Subject: UniStar Nuclear Energy, NRC Docket No. 52-016
Response to Request for Additional Information for the
Calvert Cliffs Nuclear Power Plant, Unit 3,
RAI 286, Ultimate Heat Sink

**Response to NRC Request for Additional Information
RAI 286, Question 09.02.05-18, Ultimate Heat Sink,
Calvert Cliffs Nuclear Power Plant, Unit 3**

Question 09.02.05-18

Figure 9.2-7 - {Raw Water and Desalinated Water Supply}

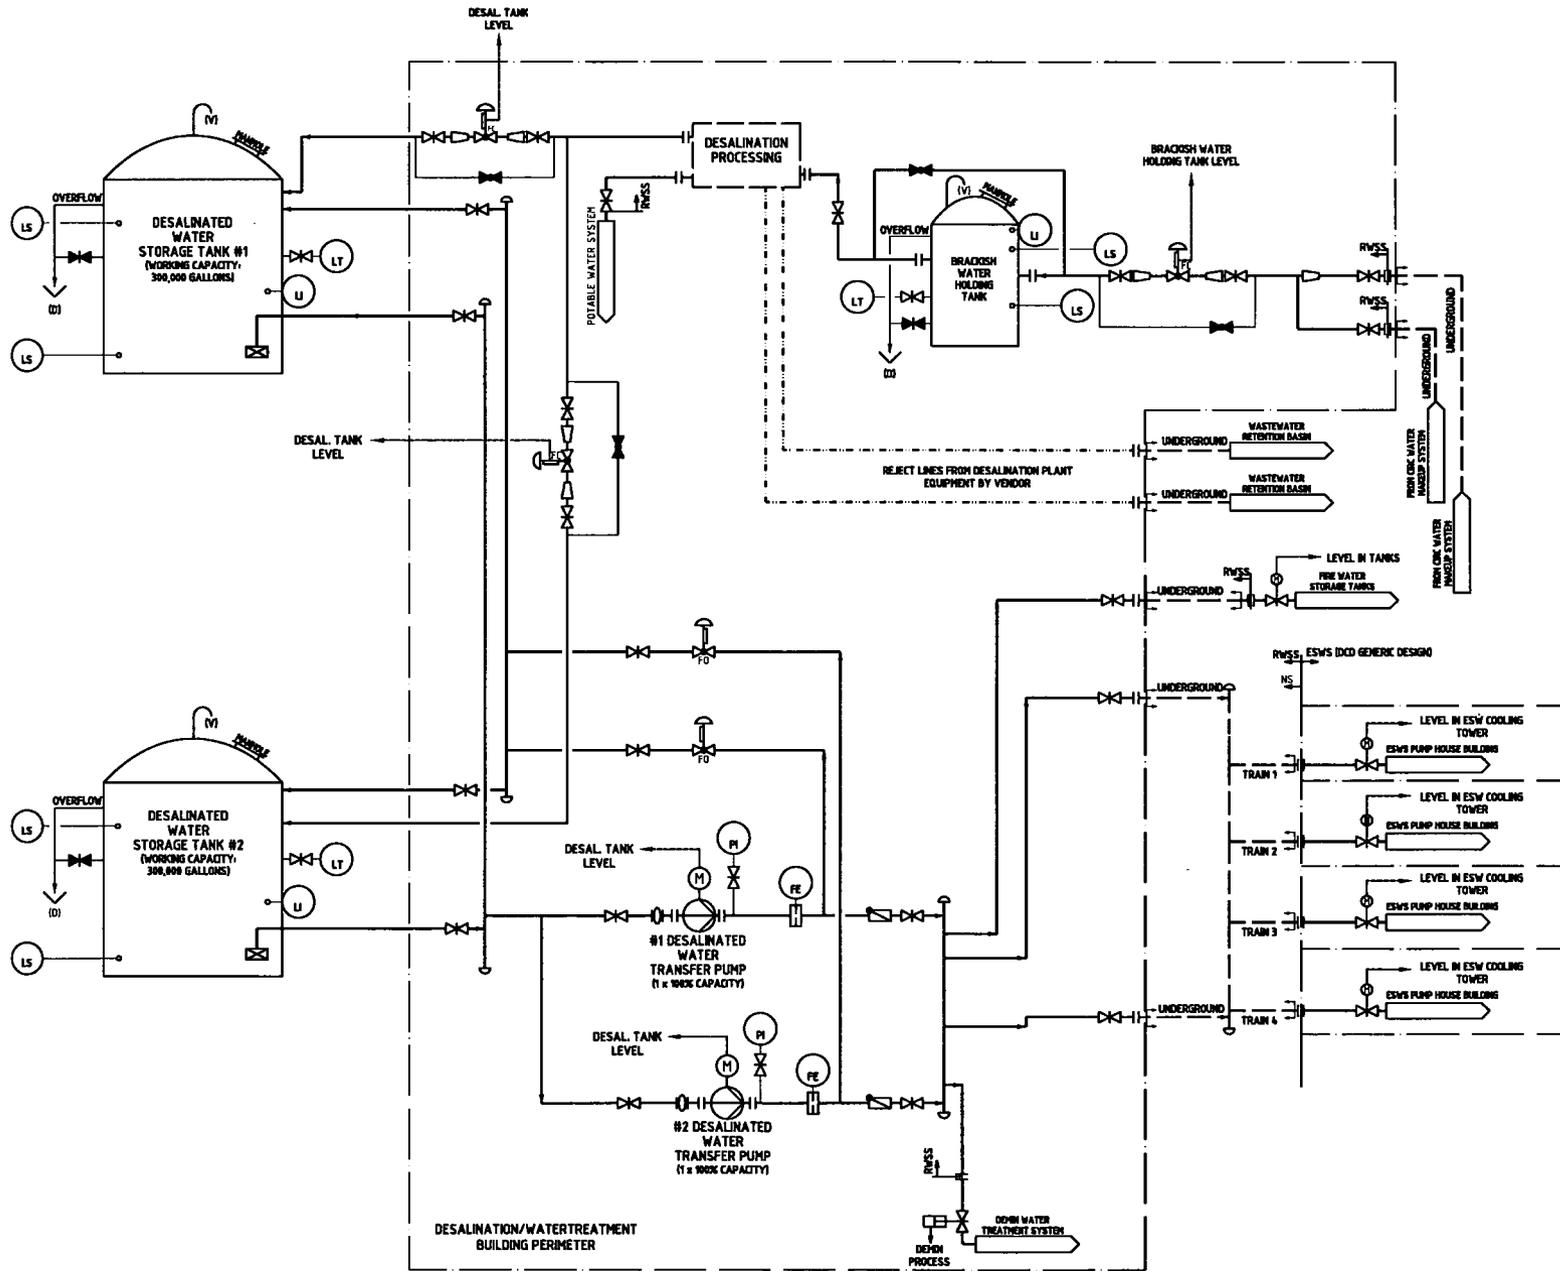
In response to the RAI, the applicant provided revised FSAR Figure 9.2-7, "Raw Water and Desalinated Water System," which indicates specific location of RWSS equipment and major isolation valves. However, the figure does not show the flow path to the potable water system. This conflicts with CCNPP Unit 3 FSAR Sections 9.2.9.2 and 9.2.9.3 which state that a second pair of 100% capacity pumps is provided for potable water demand. The applicant should provide information that reconciles this apparent conflict.

The revised FSAR Section 14.2.14.1 adequately describes the standby desalinated water transfer pump's automatic start upon sensing a low discharge pressure or upon the trip of the desalinated water transfer pump. The applicant stated in its response that Section 9.2.9.3 would be revised to remove the 'desalinated water transfer pumps - Potable Water.' However, this FSAR markup was not provided as part of the RAI response. Revision 7 of the COL FSAR states that "a second pair of 100% capacity pumps is provided for potable water demand". Therefore, this markup should be provided or provide a clarification to this statement from part 10 of this RAI response.

FSAR Figure 9.2-7 indicates a flow path to the Potable Water System from the desalination processing of the RWSS. The details of the Potable Water System, including two 100% capacity Potable Water Transfer Pumps, are shown in FSAR Figure 9.2-1.

In the response to CCNPP Unit 3 RAI 171, Question 09.02.05-2, bullet 10, the last paragraph is changed to read, "FSAR Figure 9.2-7 has also been revised to remove the 'desalinated water transfer pumps – Potable water', which are part of Potable and Sanitary water system and not part of the RWSS."

FSAR Figure 9.2-7 is being replaced with the following:
